STAFF REPORT

APPLICATION PCA 86-W-001-12 and FDPA 86-W-001-07

OVERALL DEVELOPMENT PLAN - LANDBAY B & C
FAIRFAX PUBLIC SAFETY HEADQUARTERS
 PCA/CDPA/FDPA
 PCA 86-W-001-12, FDPA 86-W-001-07
 BRADDOCK DISTRICT - FAIRFAX COUNTY, VIRGINIA

SUSTAINABLE PRACTICES PLAN

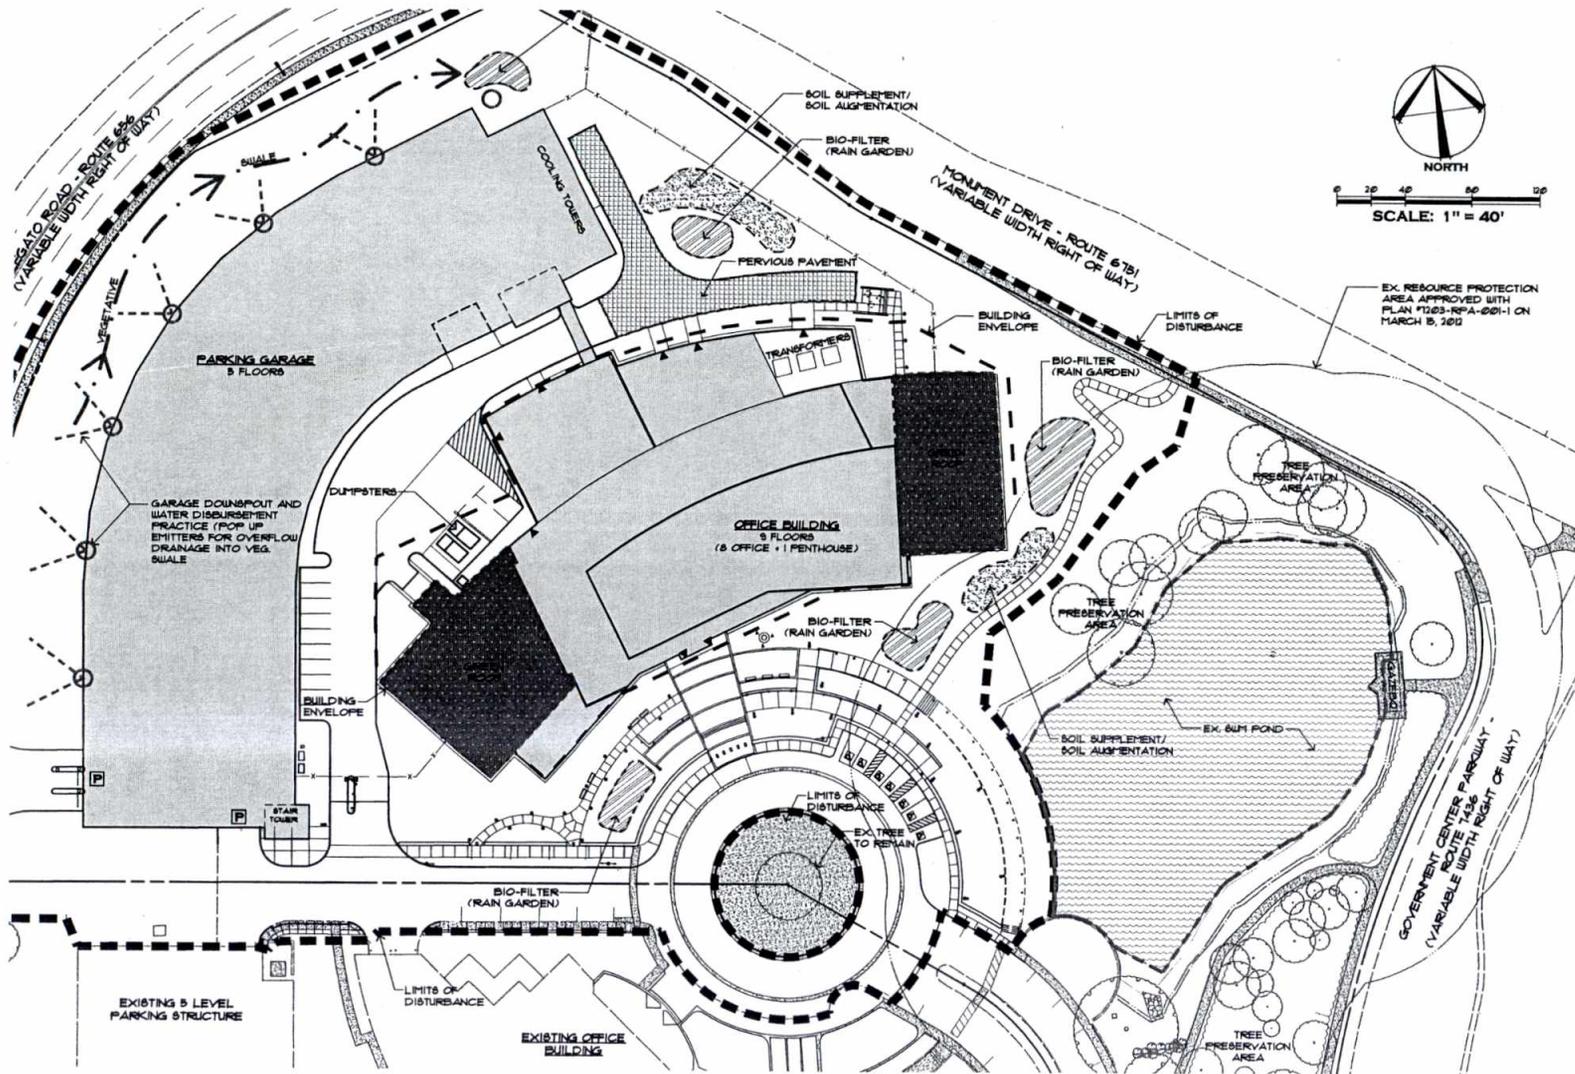
The proposed rain gardens are shown on the plan, but the proffer language committing to providing these facilities should be strengthened. While possibly not needed to achieve LEED Silver, these facilities are recognized as important features in the Fairfax Center Area. Four rain garden locations are proposed; if not all of these rain gardens are needed, preference should be given to the locations not in the RPA. Staff has included a development condition to ensure that preference is given to the

The applicant is proposing vegetated roofs on the lower roof areas of the building, which would provide additional water quantity management onsite before entering the stormwater pond. The applicant states that the vegetated roofs will cover the flanks of the building (the lower areas of the building, exclusive of the 10-story tower). Although previous versions of the CDP/FDP identified a green roof area of 12,000 square feet, this square footage was removed from the CDP/FDP and a minimum area of 10,000 square feet has been included in the proffers. Staff urges the applicant to consider the extent of green roof that can be provided and increase the proffered square footage to the extent possible.

Staff is supportive of the low impact features the applicant is proposing; however, it is recommended that the applicant achieve both the stormwater management credits within the LEED-NC checklist (credits 6.1 & 6.2) in order to provide a measurable objective in achieving the higher water quality and quantity recommendations of the Fairfax Center Area.

ELEVATION OF PROPOSED GARAGE - LANDSCAPE BUFFER

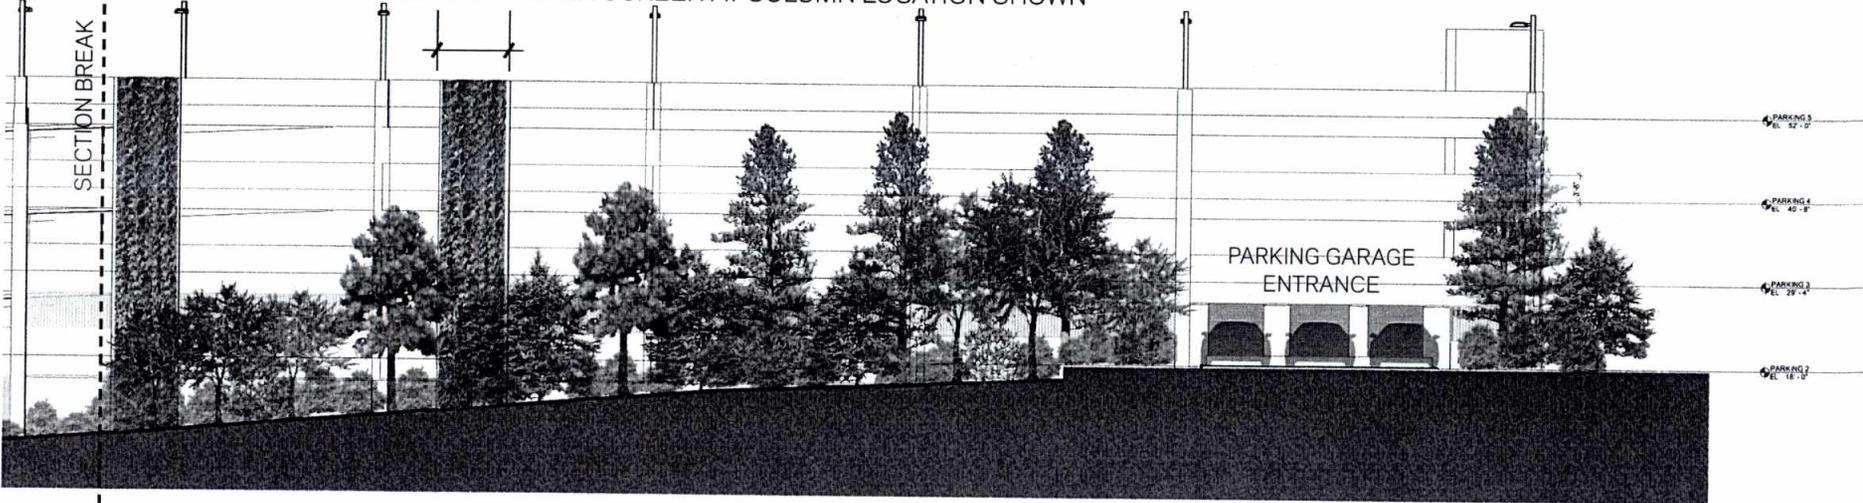
Resolution: In the current CDP/FDP submission, the applicant provided details on a green screen wall to be placed along the Legato Road garage elevation. However, this green screen wall may extend too far off of the face of the garage and may impact the 5' clear zone required as part of the sight distance line. Staff appreciates the applicant's attempt at addressing this comment; however, enough time has not been allotted to review the proposal and make a recommendation based on the concerns of other reviewing agencies prior to the publication of the staff report.
